**ADDENDUM  
NO. 9**

**June 17, 2022**

**Greenfield Central High School Auditorium Renovation and  
Addition – Bid Package No. 2  
810 N. Broadway  
Greenfield, IN 46140**

**PROJECT: GREENFIELD CENTRAL – AUDITORIUM RENOVATION AND ADDITION**

**1 LIGHTING PLAN - SECOND FLOOR - UNIT L**  
SCALE: 3/32" = 1'-0"

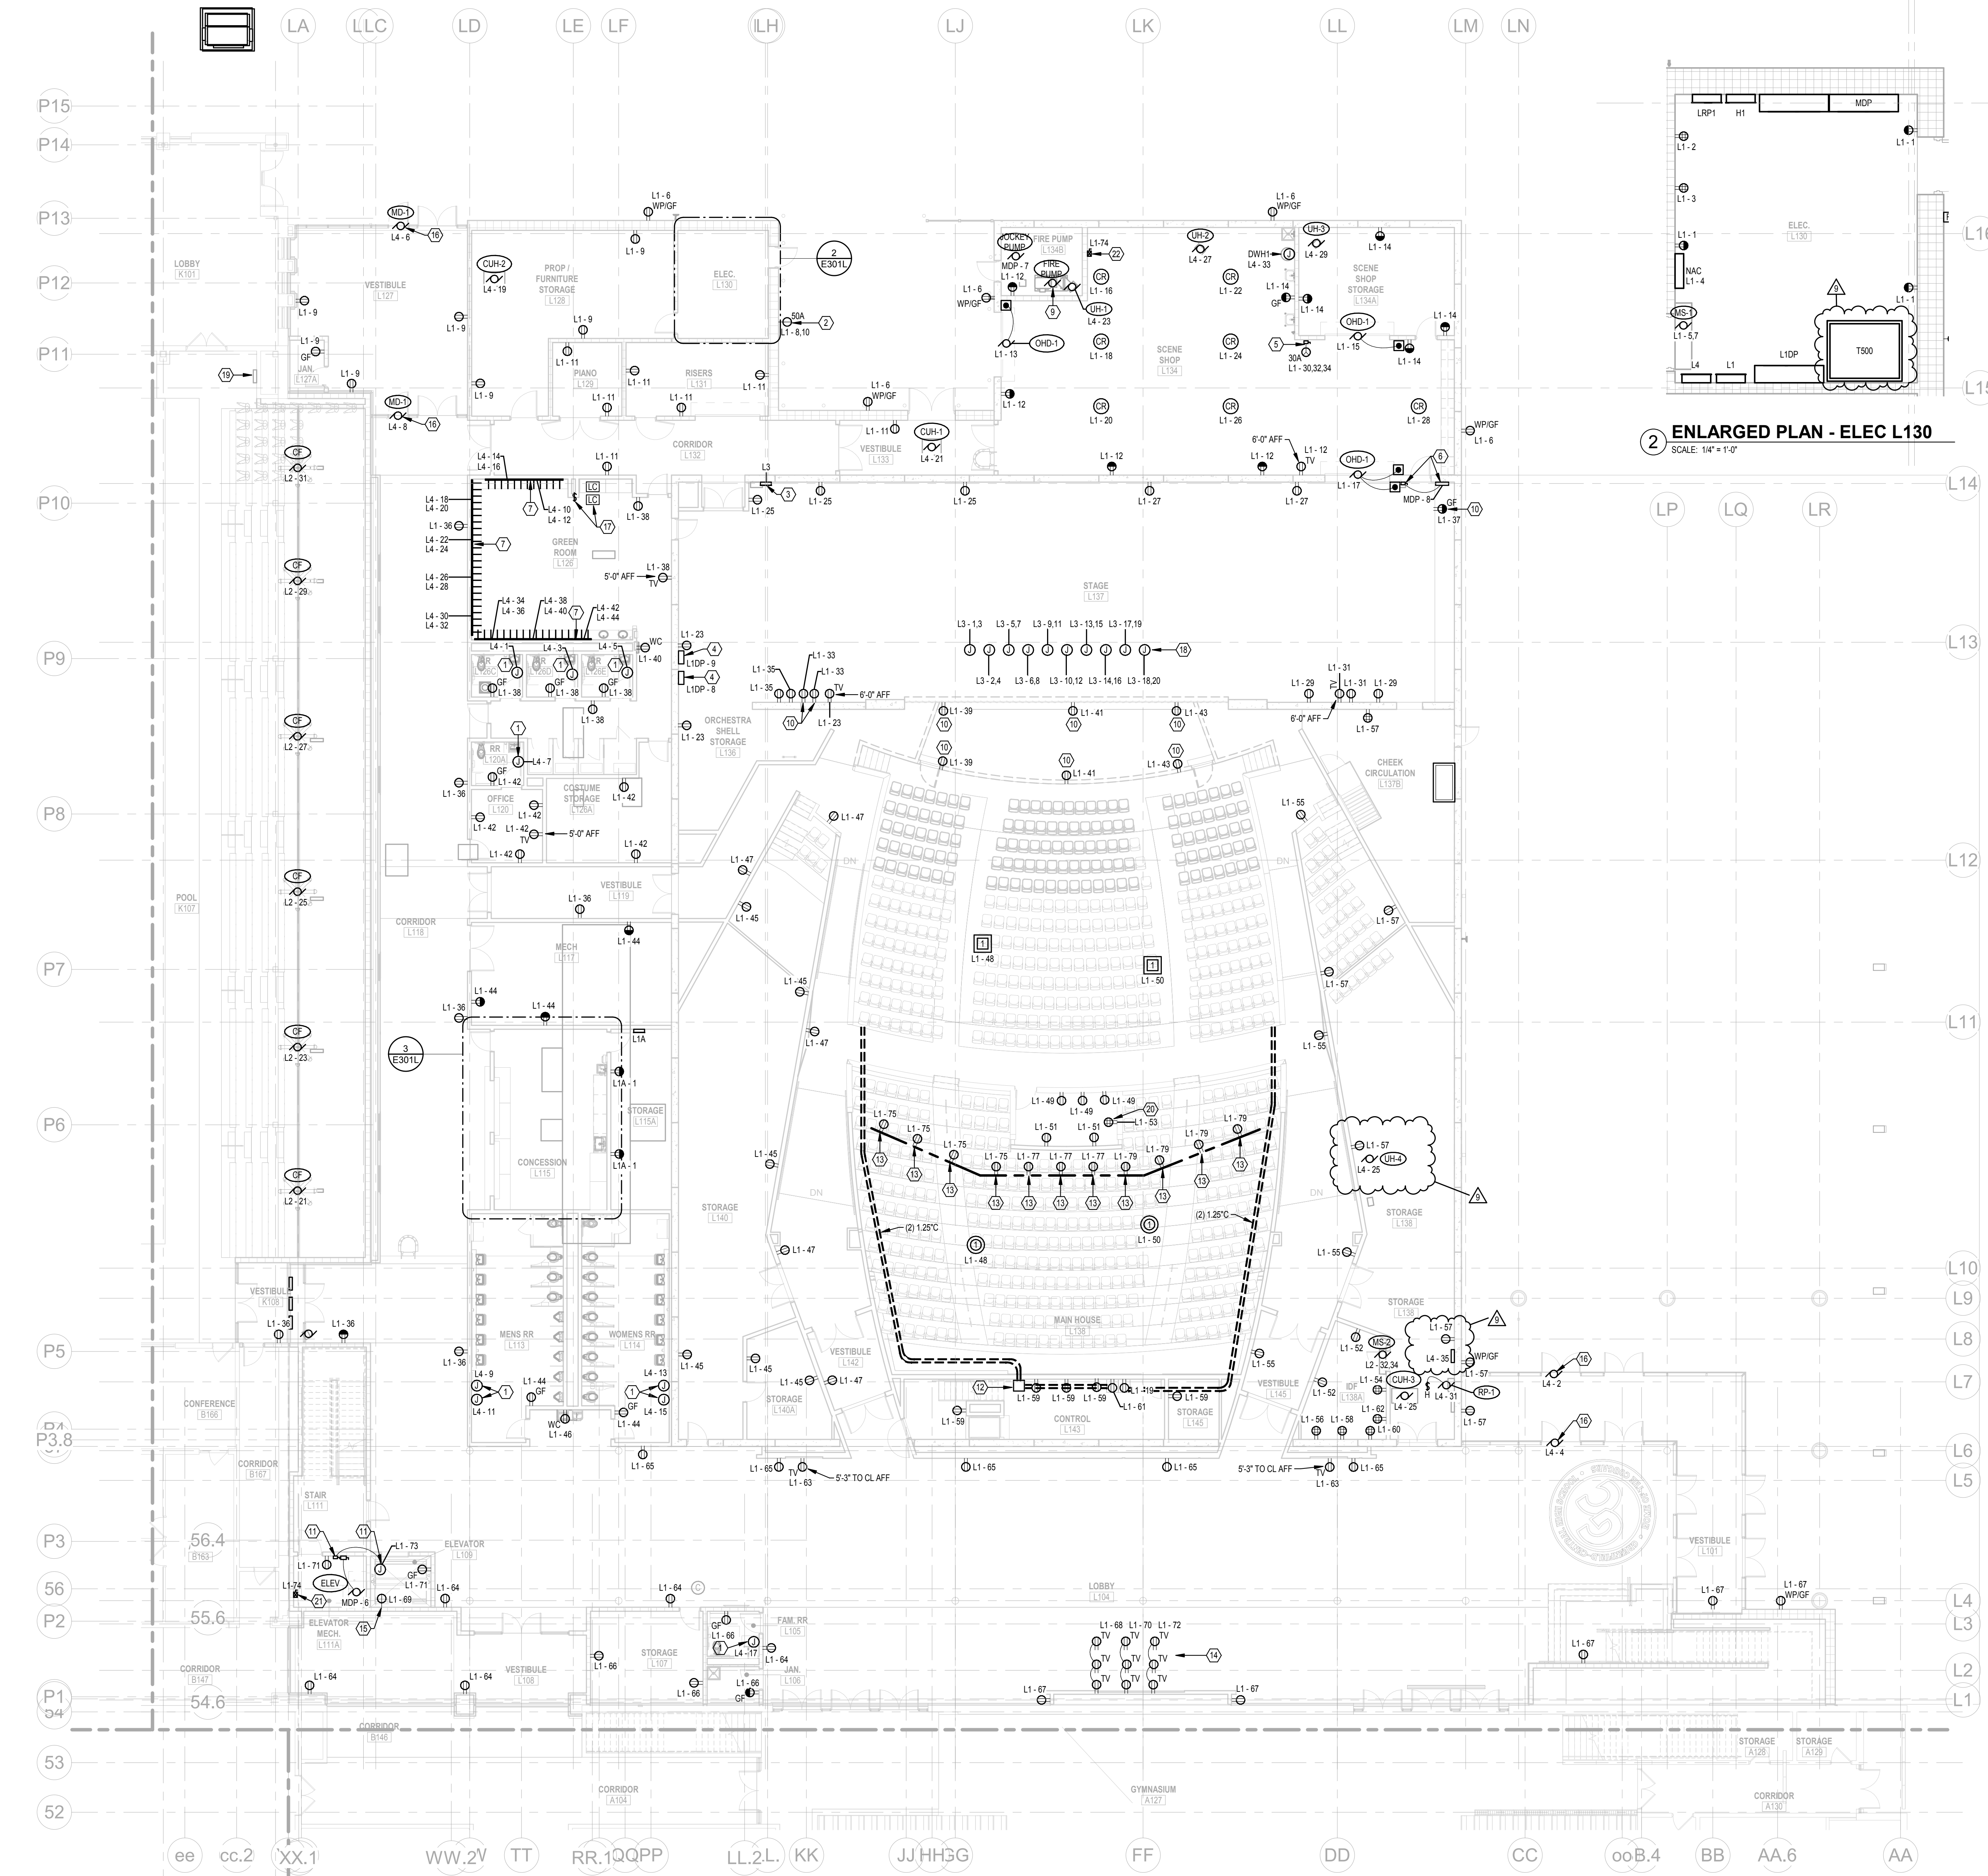
ITEM NO.1 E202L LIGHTING PLAN – SECOND FLOOR – UNIT L

- A. Revise size and layout of fixtures M1, M2, M3, M4, M5, and M6.

1 POWER PLAN - SECOND FLOOR - UNIT L  
SCALE: 3/32" = 1'-0"

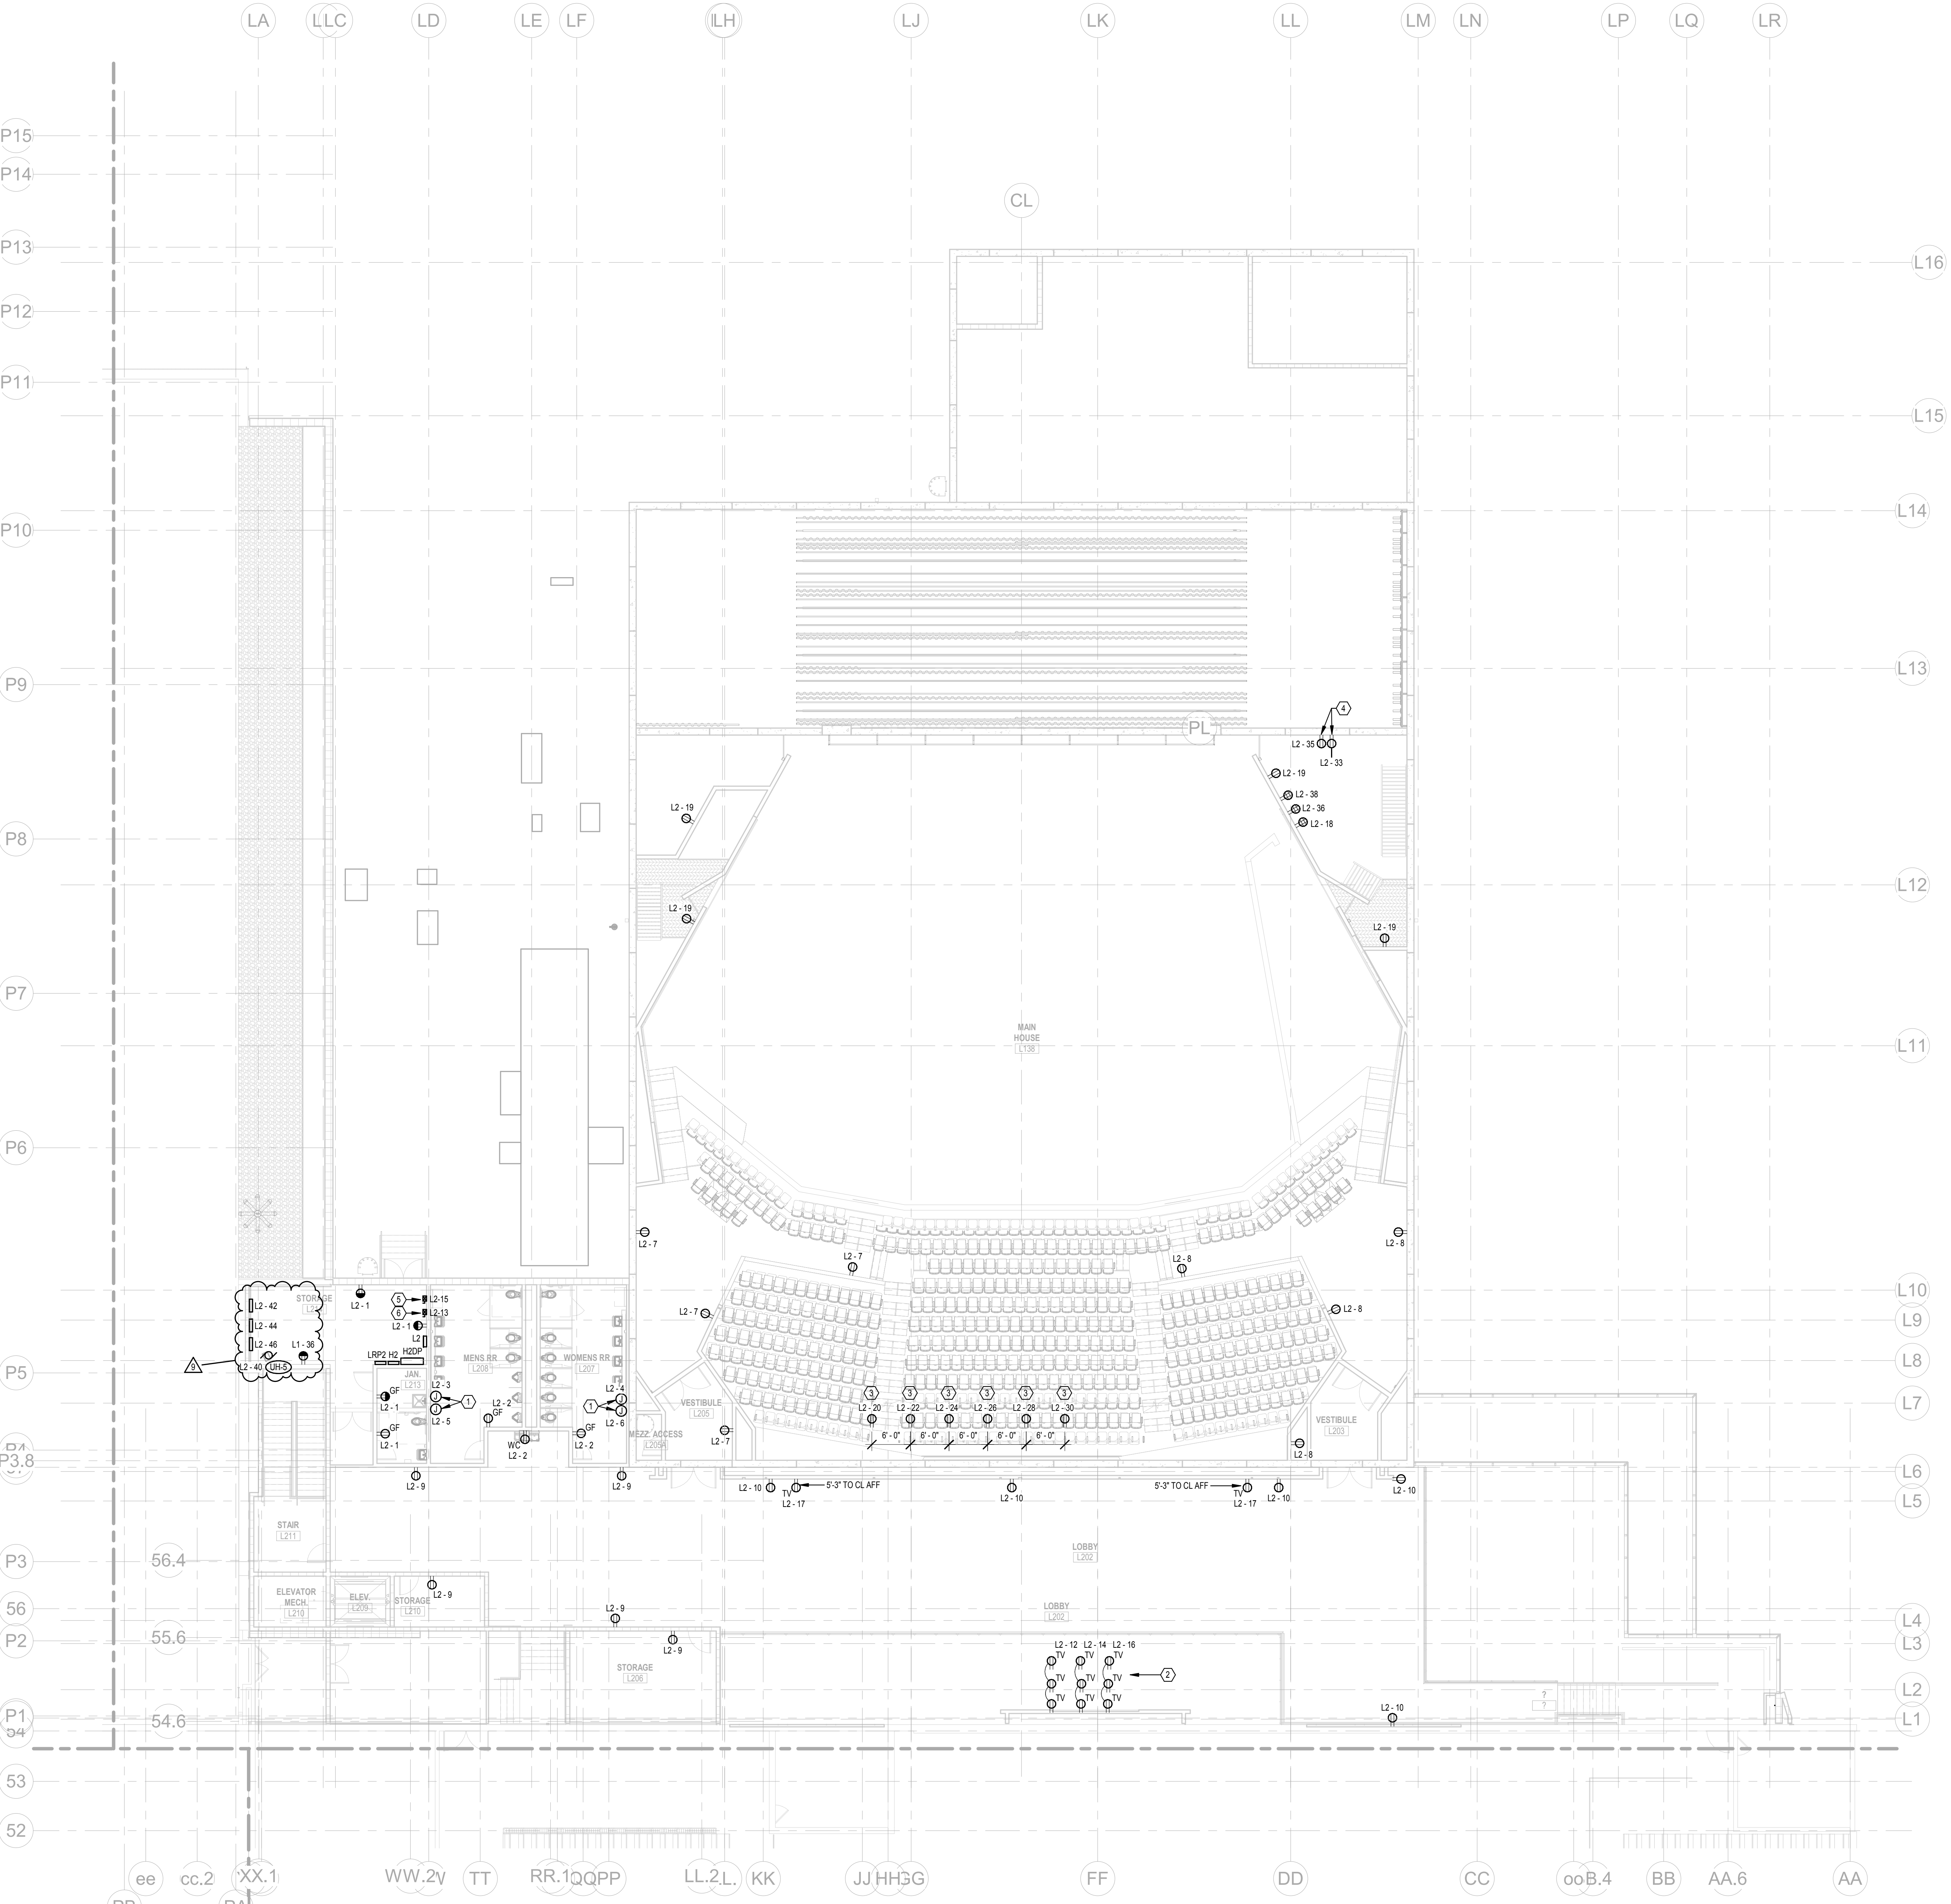
ITEM NO. 3 E302L POWER PLAN – SECOND FLOOR – UNIT L

- A. Add unit heater UH-5.
- B. Added TCP panels in L214.

**E303L**  
TRUE NORTH

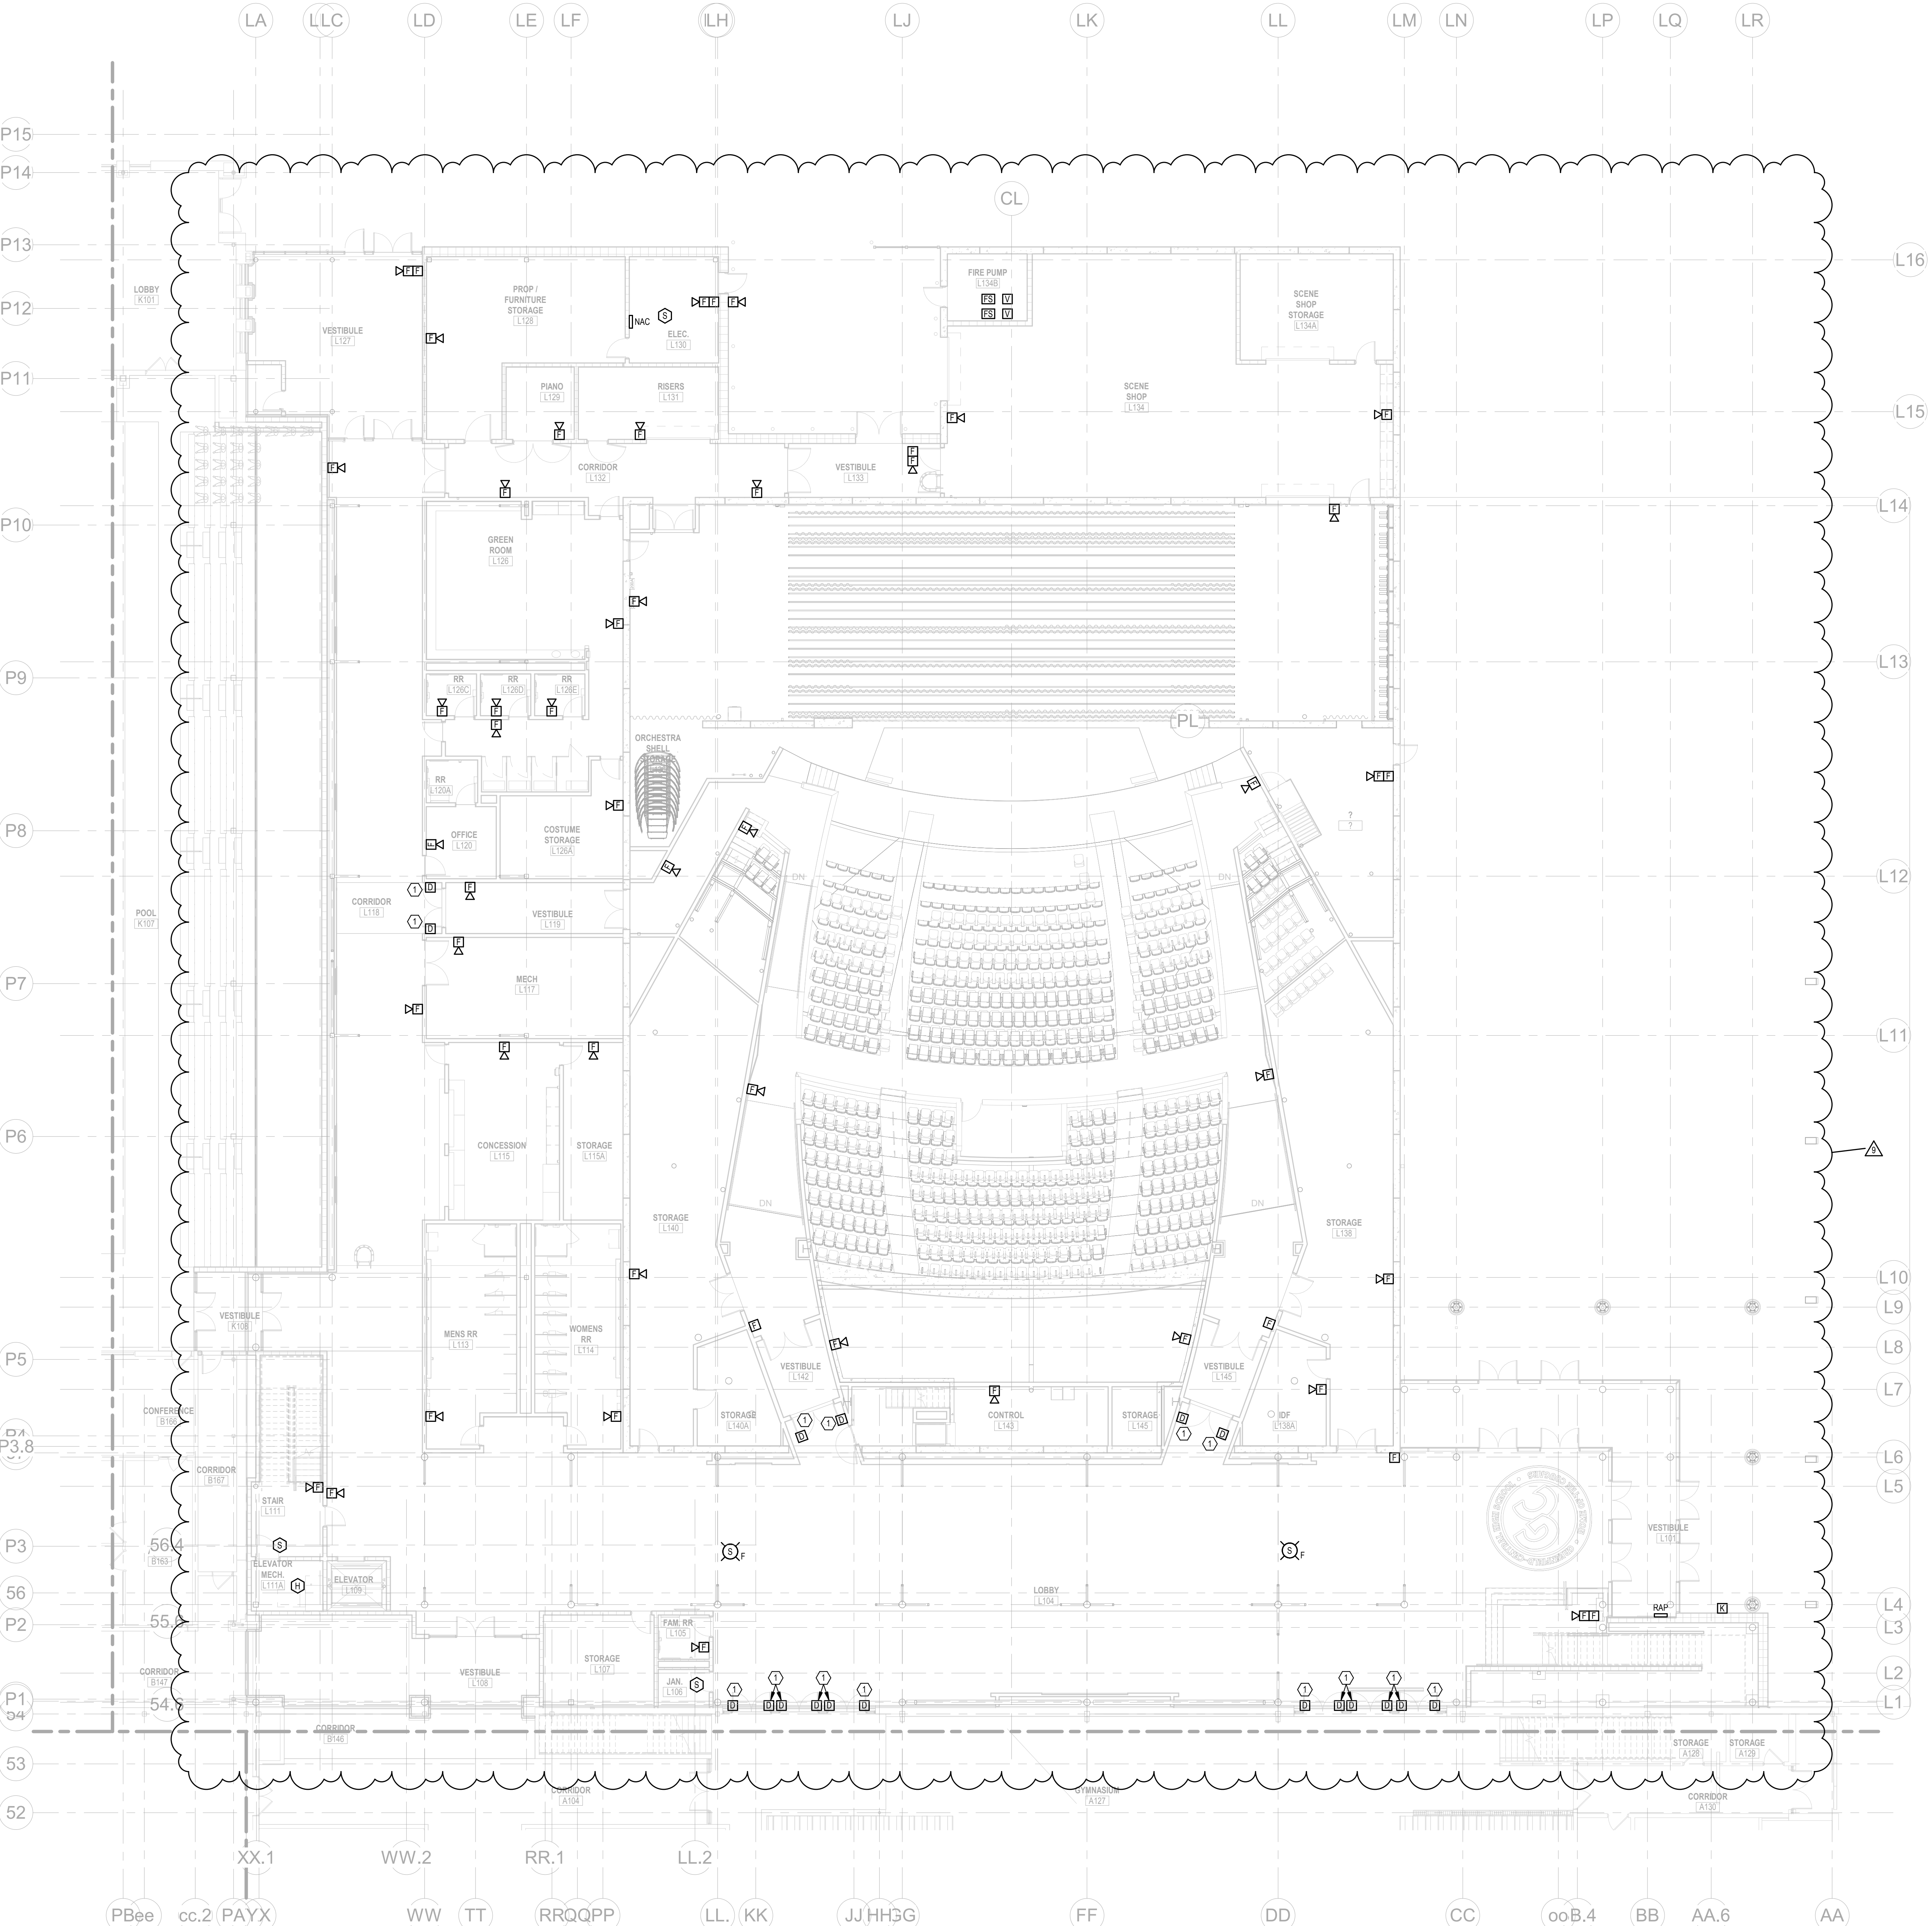
ITEM NO. 4 E303L POWER PLAN – ROOF – UNIT L
